STAFF REPORT: 10/13/2021 MEEETING

ADDRESS: 1427 RANDOLPH

HISTORIC DISTRICT: MADISON-HARMONIE

SCOPE: REPLACE STOREFRONT AND WINDOWS AT FRONT ELEVATION

Sheet #: **A3**

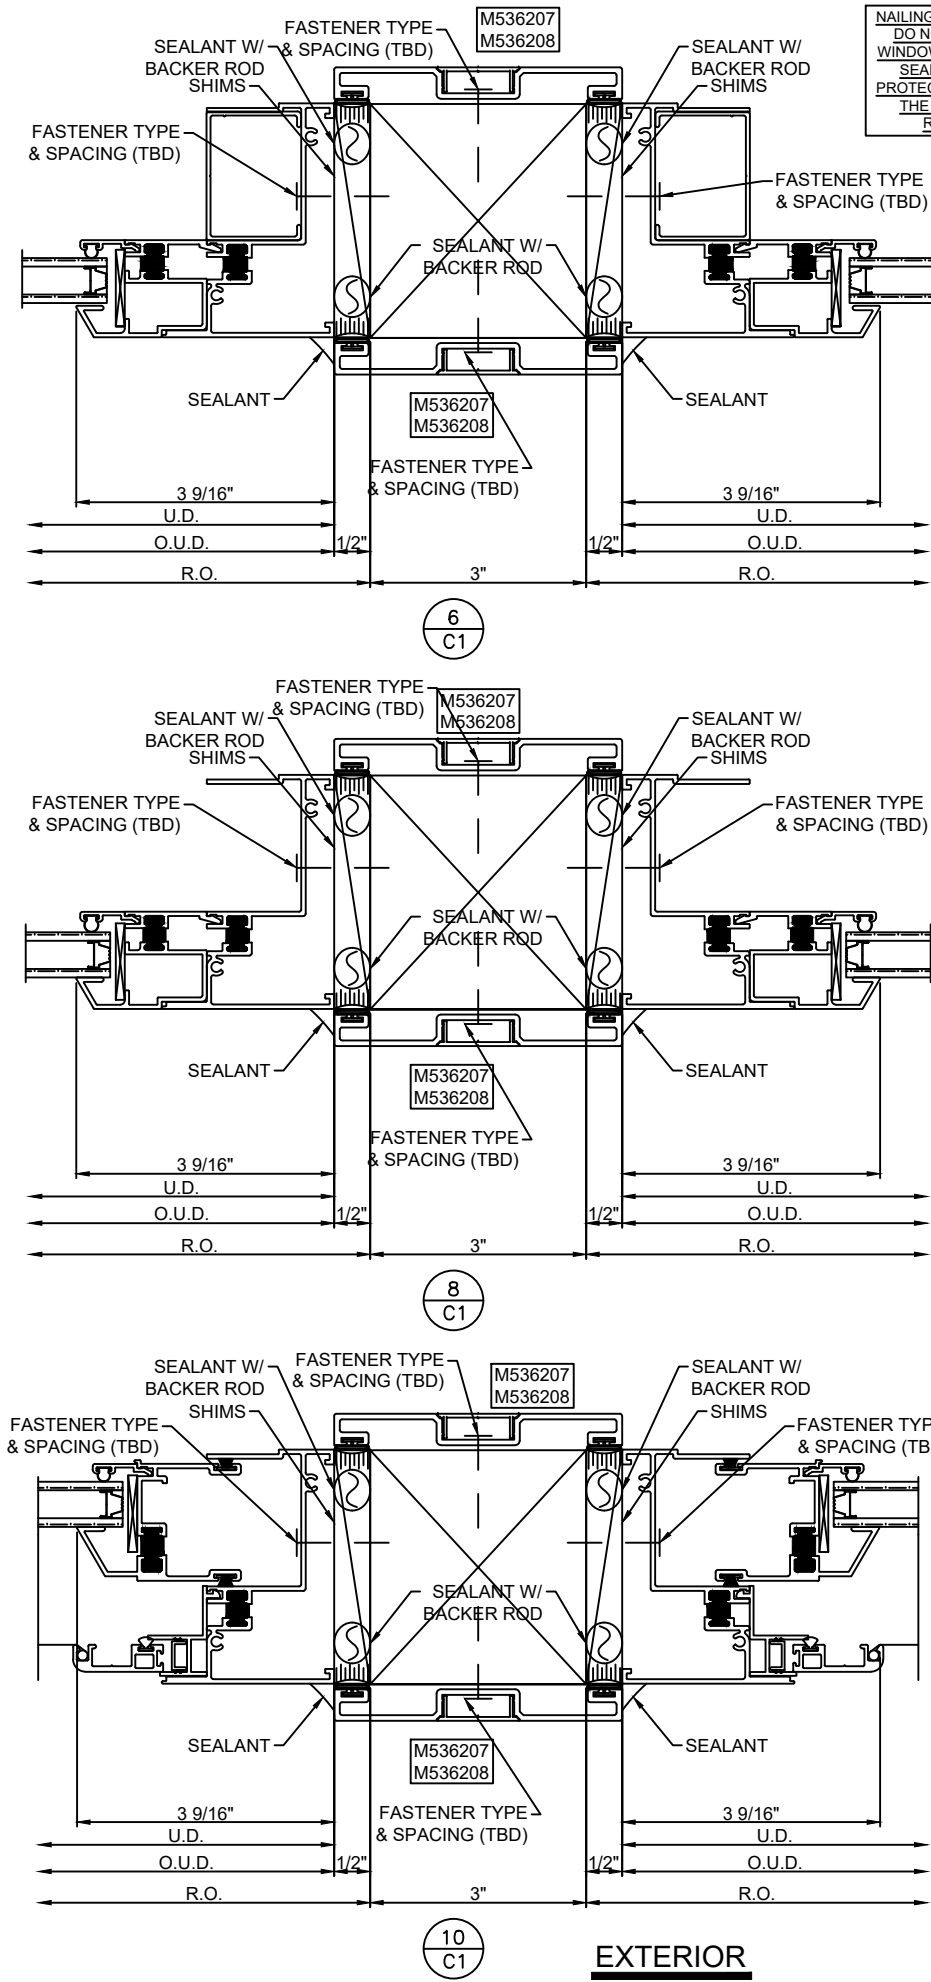
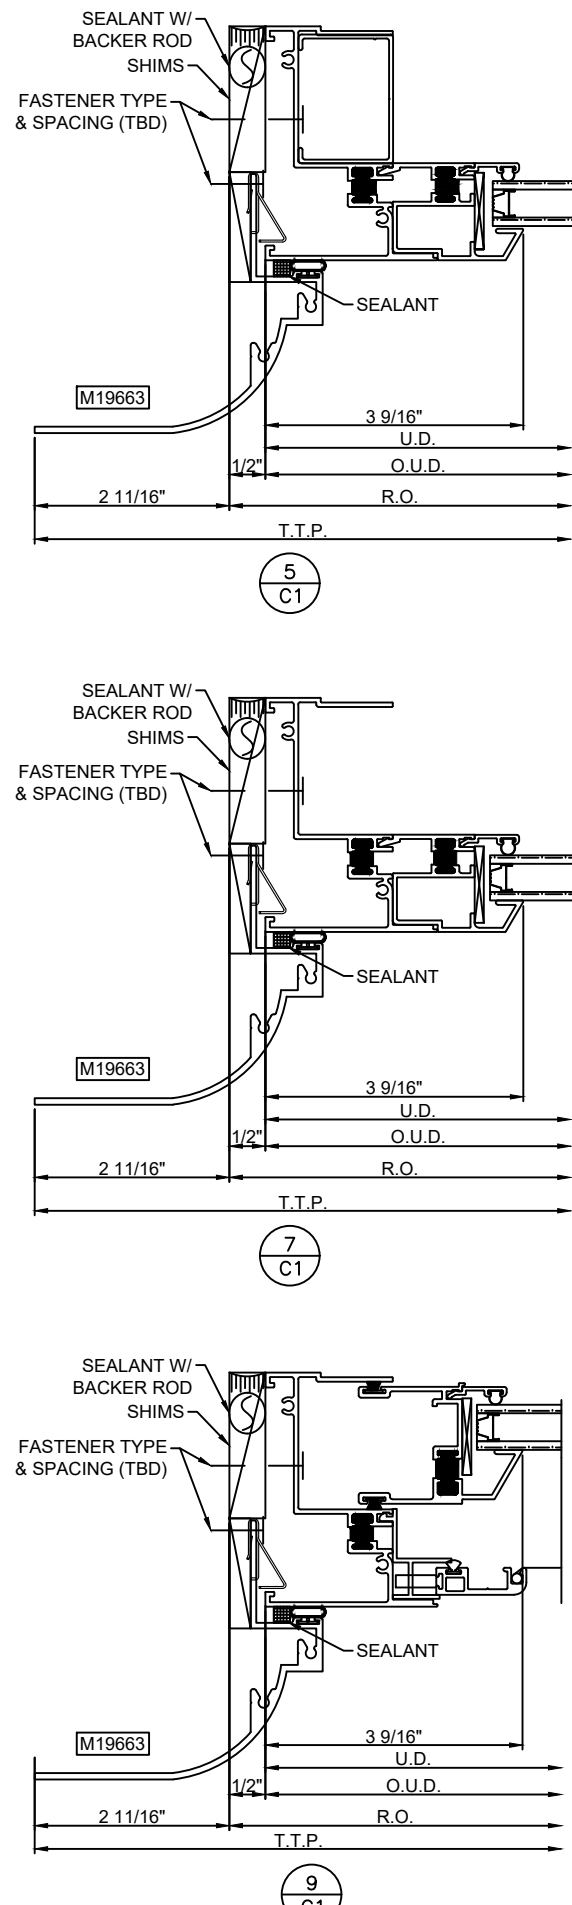
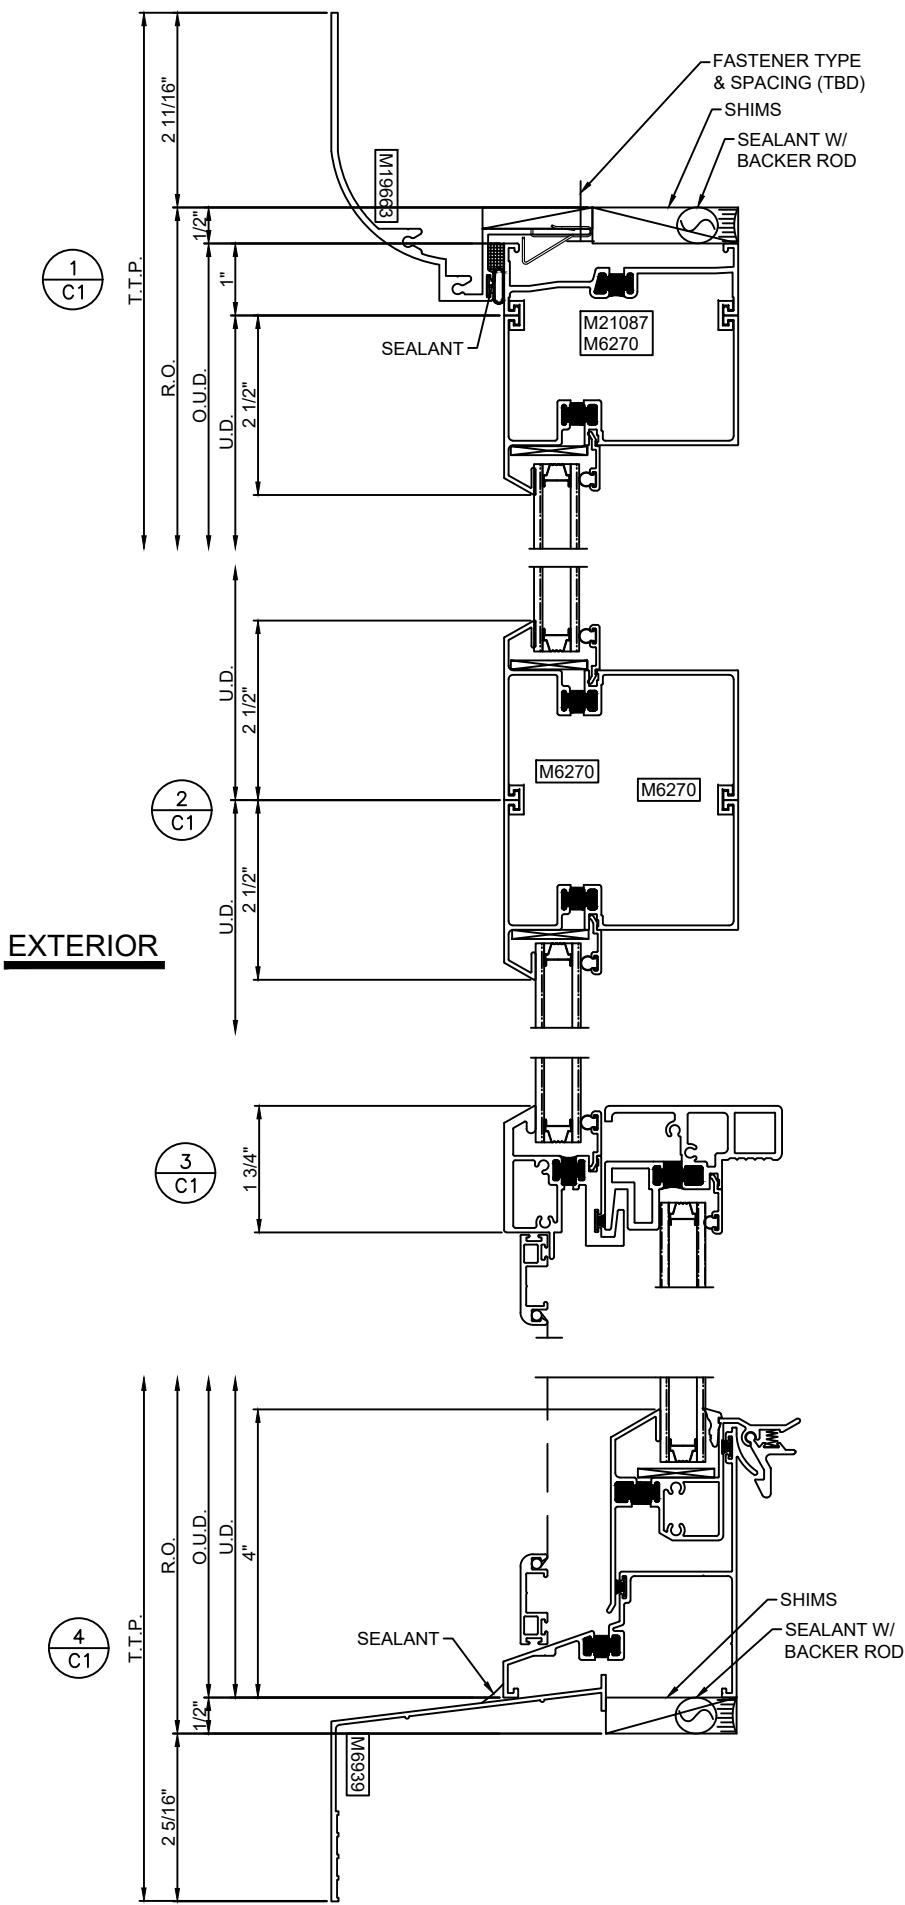
- Finally, if the Commission does determine that the current second- and third-story historic wood windows merit removal, it is unclear to staff if the proposed new windows are an exact replication of the existing historic wood windows (to include the 1/1 double-hung sash, transom, and trim/brickmould). While the application includes details/dimensions for the proposed new Quaker windows, it does not include comparable information for the existing historic fenestration. Staff did request that the applicant provide the dimensional details for the existing historic windows. However, staff has yet to receive this information as of the date of this report's completion.

- It is staff's opinion that the existing historic wood windows at the second and third story are significant character-defining elements at the building and it is unclear to staff that the windows are deteriorated to an extent that merits their wholesale removal. Therefore, their replacement would not meet the Standards.
- If the Commission does determine that the current second- and third-story historic wood windows merit removal, it is unclear to staff if the proposed new windows are an exact replication of the existing historic wood windows (to include the 1/1 double-hung sash, transom, and trim/brickmould) as the current application does not provide documentation of this fact

However, staff recommends that the Commission *deny* the issuance of a COA for the replacement of the existing historic wood windows as proposed at the second and third story, primary elevation

DATE: 9-28-2021

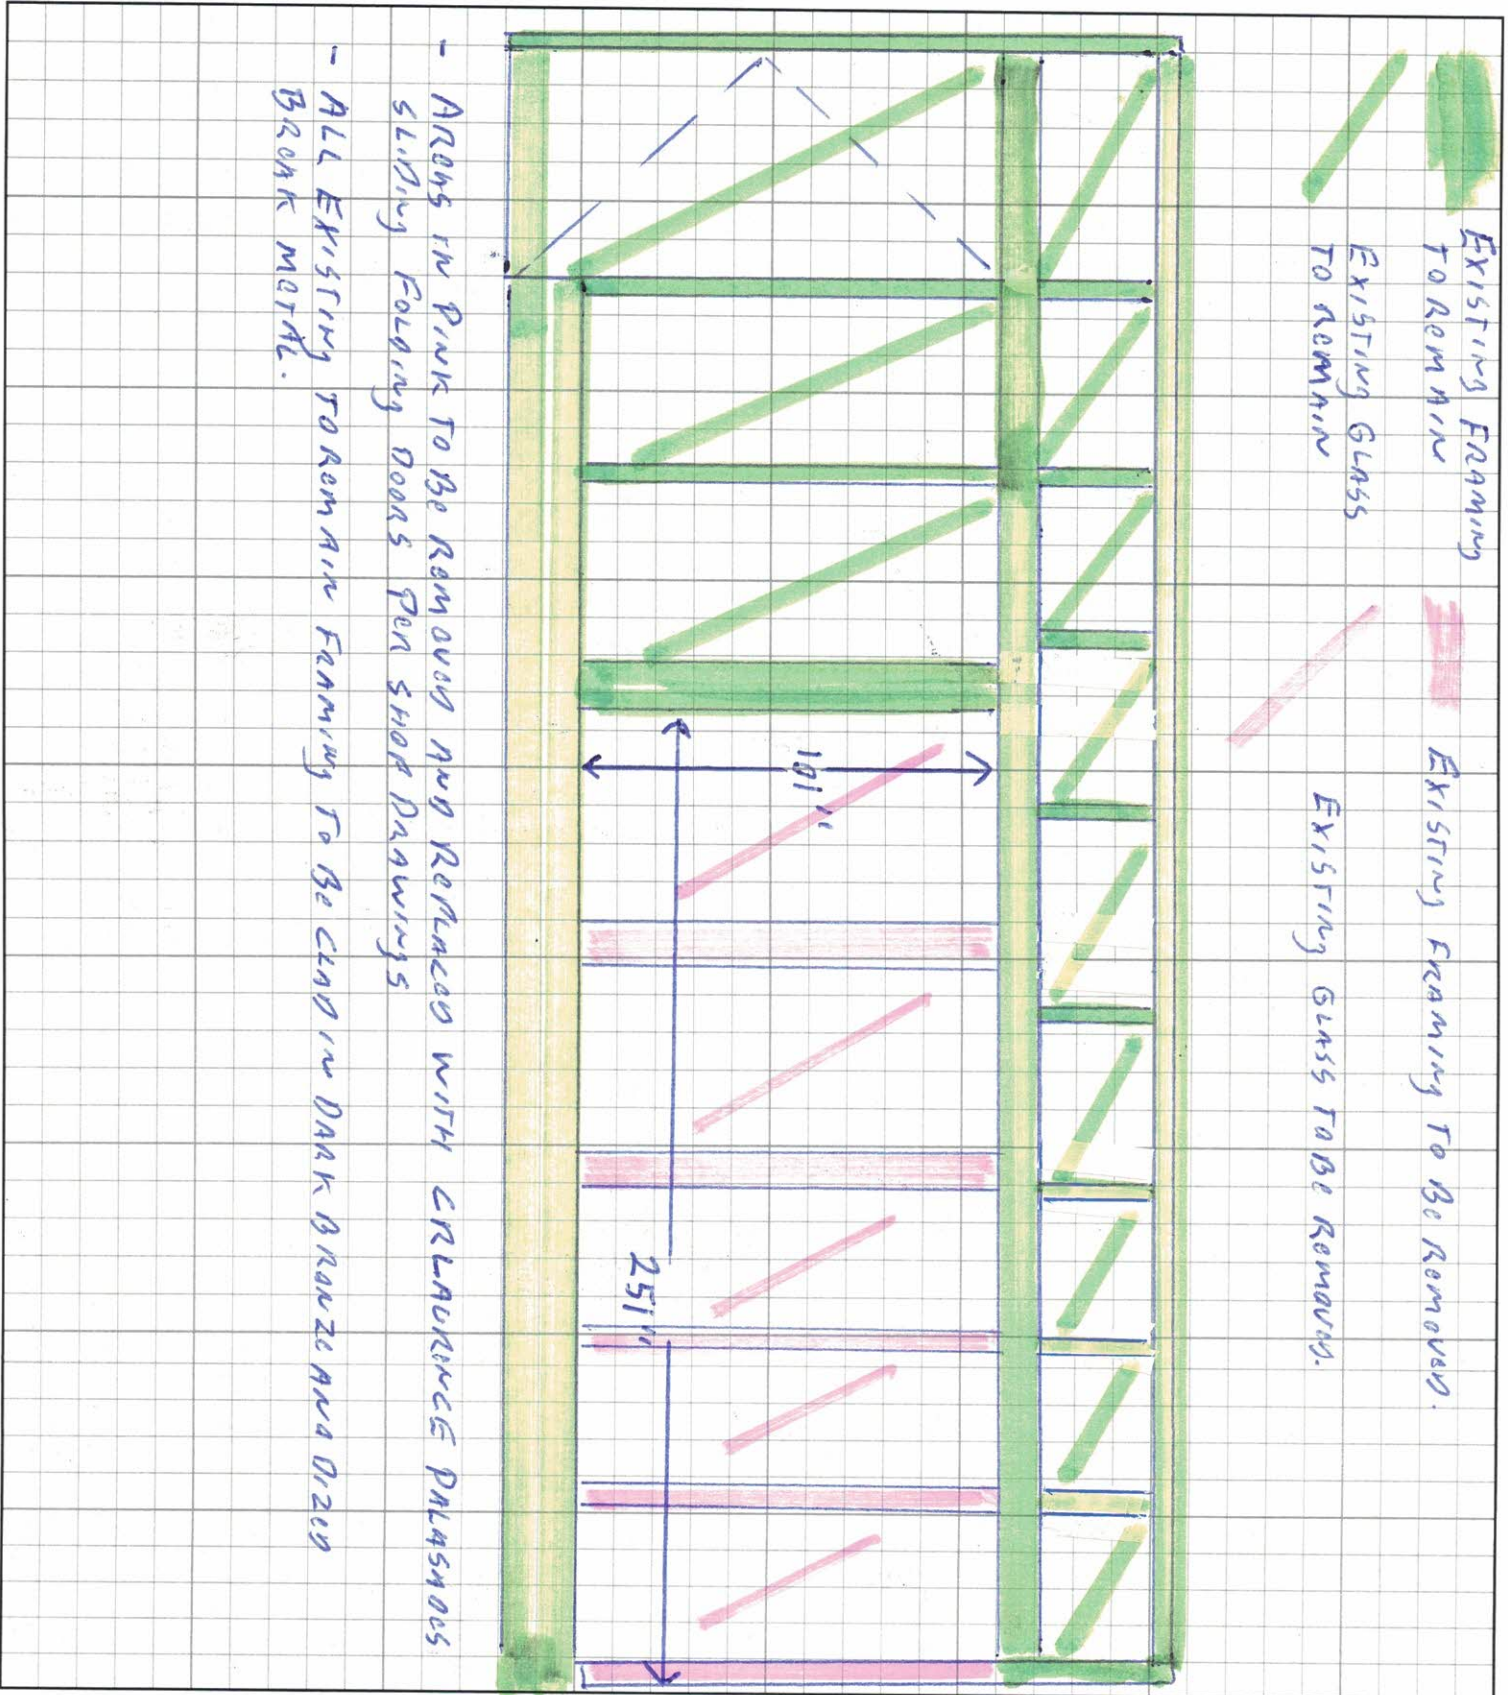
Please see attached elevation drawing of the 1st floor front of the building. We have noted areas of existing materials that will remain, and the areas that will be removed. The areas in pink will receive the new sliding folding doors per previously submitted product information, shop drawings, and details.

- We propose complete removal of Select modern storefront assemblies.
- Provide and install new aluminum and glass sliding /folding doors at select location.
- Provide and install new dark bronze anodized aluminum break shapes to clad all existing storefront mullions and wood areas.
- All perimeters will be sealed using polyurethane caulk.

Staff recommends that the Commission issue a Certificate of Appropriateness (COA) for the following work item because it conforms to the district's Elements of Design and meets the Secretary of the Interior (SOI) Standards for Rehabilitation:

- At the front elevation, remove the five southernmost existing non-historic wood storefront panels at first story and replace with a new CR Laurence Palisades Series S90 aluminum bottom rolling sliding folding door system which measures 20'-10" x 8'-4". Framing and doors will be black powder coated aluminum, all glass will be clear tempered insulated with dual silver low-e coating. System will consist of 6 panels that slide and fold to the Right and inside stack with 2 point locks (no exterior access).
- At the front elevation reclad remaining non-historic wood storefront with aluminum, color black per the submitted project narrative, so that its appearance matches the new bifold doors.
